November 11, 2025

Re: North Clinton Avenue Milling and Resurfacing Project Proposal of 2025.10.07

Figure 1: Our proposal for the intersection of N Clinton and Ward St. The red lines represent extensions to the textured & colored concrete buffer. The yellow boxes represent detectable edges. The orange box represents our recommendation to move the southbound bus stop to be an in-lane stop.

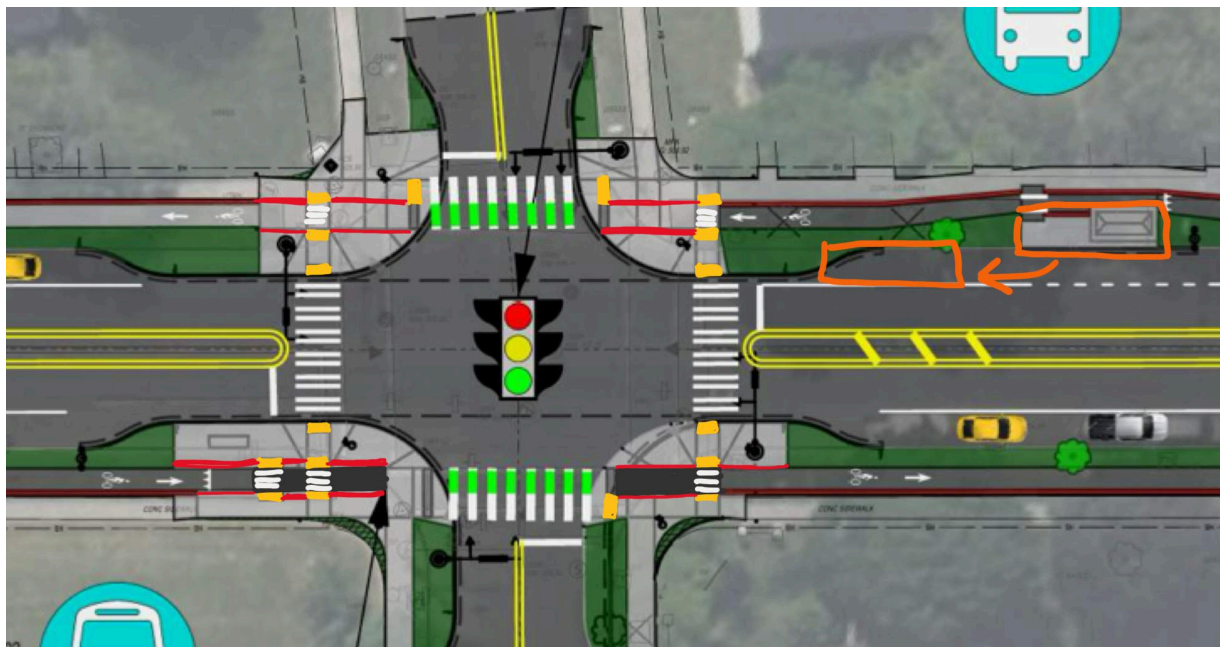
Thank you for including several floating bus stops similar to what is described in section 7.9.14 of the 2025 AASHTO Bike Guide. This is the best design solution to minimise conflicts between cyclists, pedestrians, and transit users and we are excited to see this design come to Rochester. In order to clearly communicate right-of-way and to minimise conflicts, we recommend adding detectable edges to areas where pedestrians and cyclists are expected to cross paths and add additional yield markings on the cycle track indicating that bikes must yield to pedestrians. The 1' colored and textured concrete buffers should be extended to the curb line marking the intended path of cyclists and pedestrians clear. Refer to our diagram below as well as page 7-57 of the 2025 AASHTO Bike Design Guide.

Figure 2: A potential configuration of the connection between the Bastian Street Bike Boulevard (blue #1 in diagram) and Darrow Street (blue #2 in diagram). The black boxes represent bus stop space.

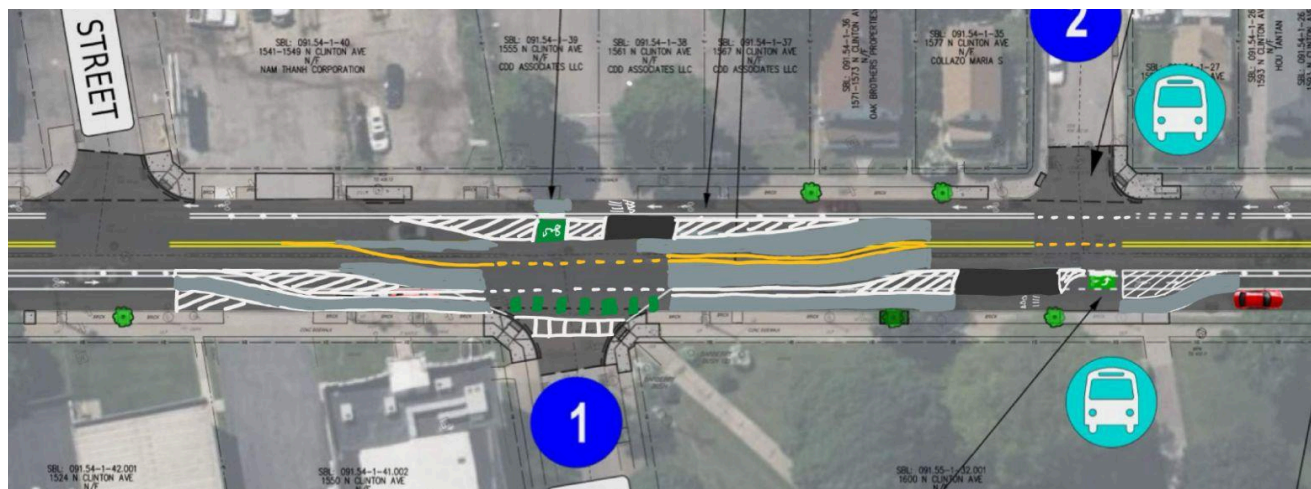
skewed nature of the intersections here makes the connection difficult, however, the connection can be made by briefly disrupting parking, shifting one bus stop, and by trialing temporary bus stop boarding islands. Our first proposal (refer to figure 2 above) would involve removing several on-street parking spaces to create room to accommodate two stage turn boxes and floating bus stop islands using low cost materials. The floating bus stops can be protected with a single concrete barrier, similar to how some Toronto street car and bus stops are (refer to

Figure 3: A low cost in-lane bus stop protected by a concrete barrier in Toronto. Cyclists use the ramp when transit vehicles are not present.

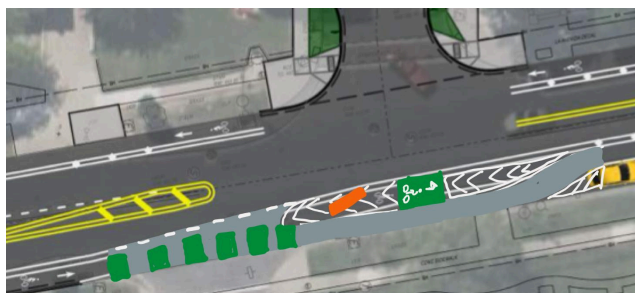
figure 3). If this is not possible, we encourage a design which includes a two way on-street bike lane between Bastian and Darrow on the east side of the street. This configuration would require a barrier between the two-way bike lane and the travel lane. Connected all-ages-all-abilities bike networks require the city of Rochester to use barriers in many locations and we encourage project managers to expand the City's toolkit.

Figure 5: Two stage turn boxes and directional curb cuts at the intersection of N Clinton & Norton

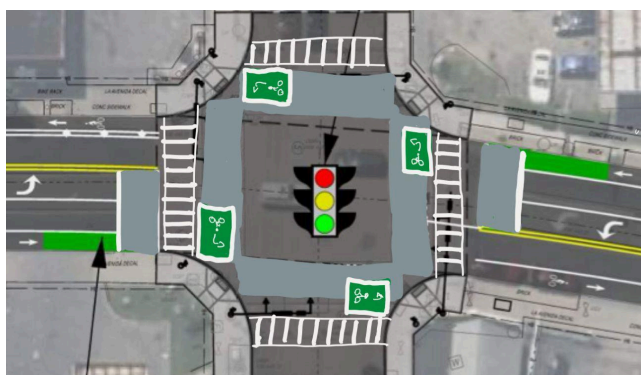
The design presented to the public at the October 7th meeting included two stage turn boxes which were placed in the bike lane. This placement goes against AASHTO design guidance and the MUTCD. Two stage turn boxes must be placed outside of the bike lane. Wherever possible, two stage turn boxes should be included opposed to traditional bike boxes as two stage turn boxes are intuitive, encourage safer turning movements, reduce cyclist

conflicts with vehicles, and don't require as much courage and cycling savvy riding. For example, two stage turn boxes could be included at the intersection of Ward Street and Norton Street. Refer to figure 5 for our proposal to accommodate two stage turn boxes by installing directional curb cuts.
